FINAL ENVIRONMENTAL IMPACT REPORT

AND RESPONSES TO PUBLIC COMMENTS

Doheny Ocean Desalination Project

SOUTH COAST WATER DISTRICT

EXHIBIT 4.7-2: Schools within 0.25 Miles of the Proposed Project

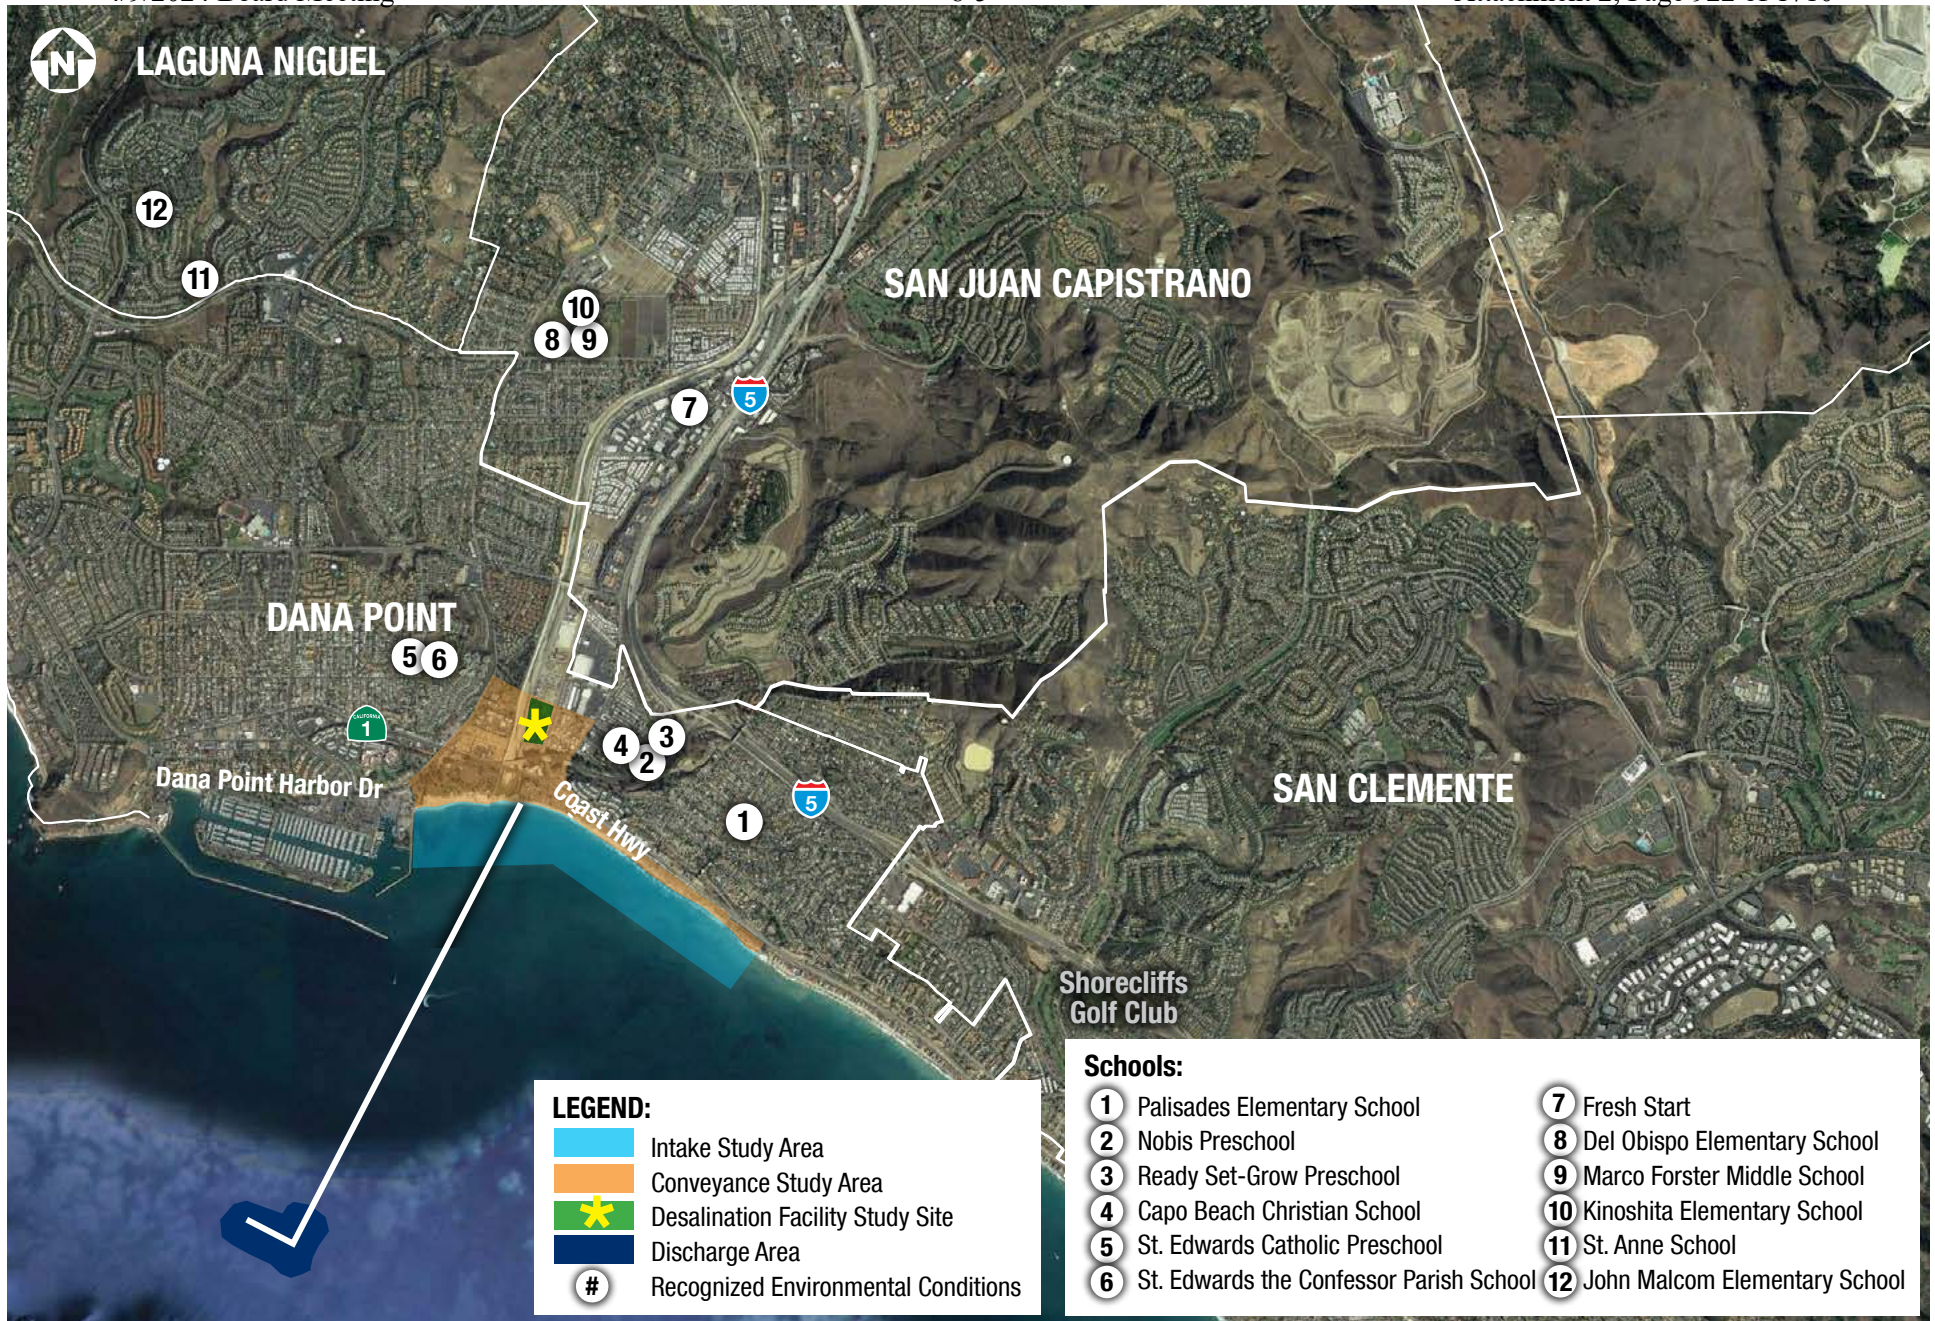
5. The OCHCA noted that the study areas depicted on Exhibit 4.7-1 do not align with those depicted on Figure 4.7-2. For the purpose of this review the OCHCA evaluated the boundaries presented on Exhibit 4.7-1. If the boundaries presented on Exhibit 4.7-1 are in error, please notify the County of Orange. 4

The boundaries on Exhibit 4.7-1 are correct. Exhibit 4.7-2 will be modified to reflect the correct boundary for the Intake Study Area and Conveyance Study Area which apparently shifted during the printing process. Refer to Section 3, *Draft EIR Errata*.

Exhibit 4.7-2 has been modified and is included in Section 3, *Draft EIR Errata*.
